82C465MVB Product Update

Revision 1.4 - April 1998

The product updates in this document refer to the OPTi 82C465MVB Single Chip Notebook Solution.

Figure 3. Correcting AEN for 16-bit DMA

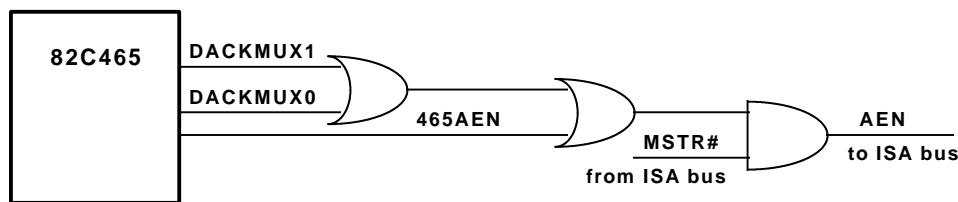
The 82C465 series drops AEN prematurely during 16-bit DMA transfers. The AEN signal should remain high at least for the duration of the ISA command lines (IORD#/IOWR#, MRD#/MWR#) during DMA. But AEN will drop low mid-way through the command, possibly allowing an I/O device to decode the transfer as a standard input/output command.

The 82C465 chip itself can decode this cycle and hang the system under certain circumstances. Generally this failure mode is evident only when writeback CPU operation is enabled.

- If there is no possibility of 16-bit DMA occurring, no workaround is required.
- If no local ISA devices will misinterpret the DMA transfer as an I/O access, it is sufficient to simply set register 43h[2:0]=000 to enable synchronous ATCLK operation. The internal logic of the 82C465 chips will not misinterpret the DMA access as an I/O access when in synchronous mode.
- If full ISA support is expected, the fix shown in the figure below must be implemented using two 7432 gates and a 7408 gate. Note that if ISA masters are not supported, the 7408 gate is not required.
